8511 15th Avenue NE | DPD Project # 3006480 | Design Review Board Recommendation Meeting 2 | April 7, 2008

C.0 SUMMARY OF DESIGN REVIEW BOARD COMMENTS

H.1 LANDSCAPE

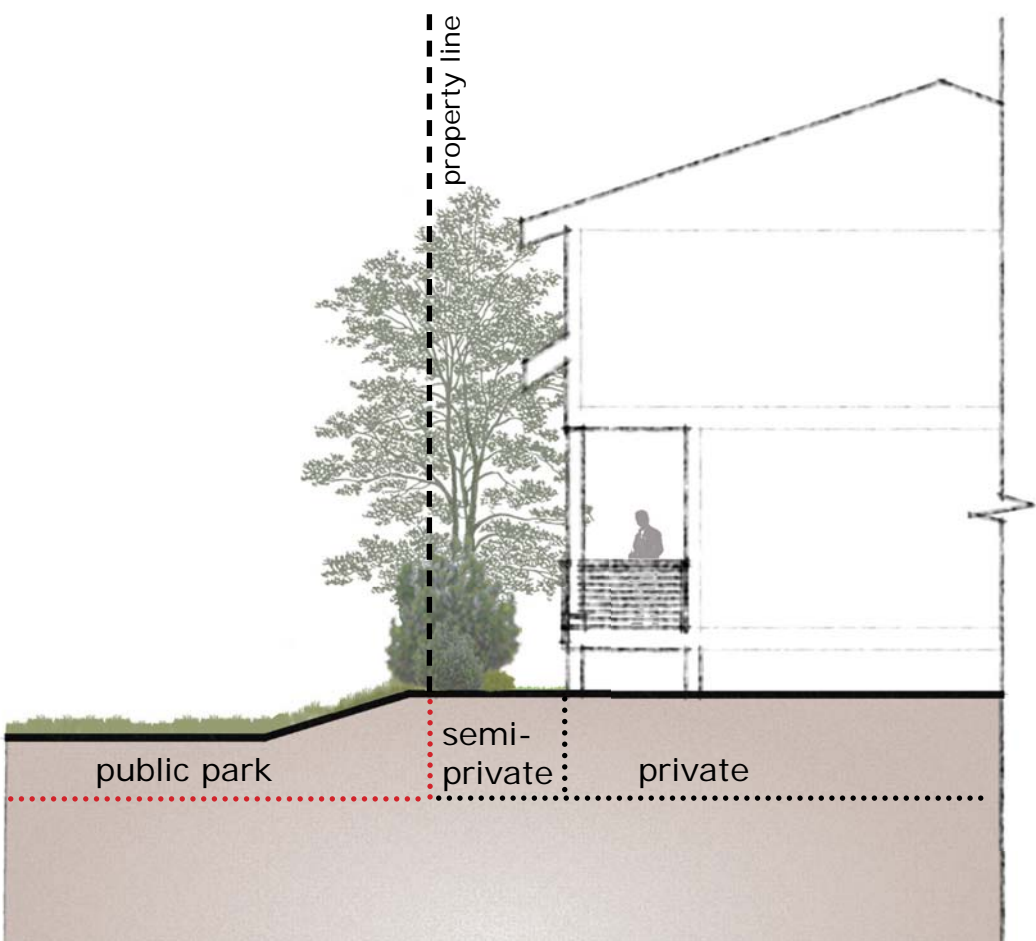
The Design Review Board would like to see fences around the site. Fences should not “wall off” the site from exterior vantage point. Consider using landscape to address the fence around the water treatment facility.

Applicant’s Reponse: The applicant has no plans to build fences around the site except where requested or required by adjacent properties. There will be privacy fences between the project site and the commercial property to the northeast and adjacent to the single-family residence to the north. The applicant has requested that SPU remove as much of the fence along the reservoir as possible when it is converted to a park. Until then, and for the portion of the fence that remains for security, the fence will be softened with landscape elements.

- Privacy fence
- • • • • Temporary Security Fence
(To be removed with development
of reservoir park)
- - - Permanent Security Fence
